Bulletin

848 Un-A-Hauler AEPB Systems

BULLETIN NO.	ORIGINAL DATE	ORIGINATOR	APPROVED	EFFECTIVE	REVISED	EFFECTIVE UNTIL
900-102308 Rev. 1	10/23/08	D. Jones	J. Rector		05/14/09

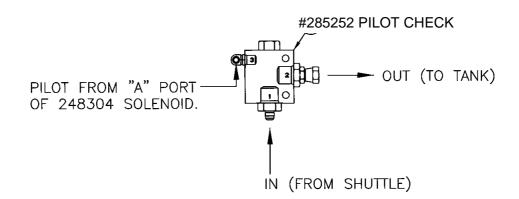
The required connection of the #241103 solenoid kit is shown below.

The original Hydraulic Schematic L-012036X1, revision D, includes specific instructions required when the #241103 Solenoid Kit is to be applied. The following related drawings have also been revised to reflect changes required when applying the #241103 solenoid kit:

When Solenoid Kit #241103 is used to replace solenoid L-H788X5, the system connections must be made in accordance with our #623842 848 Brake System Diagram (241103 Solenoid Update).

Dwg. #241103, revision D

Dwg. #623842, revision C
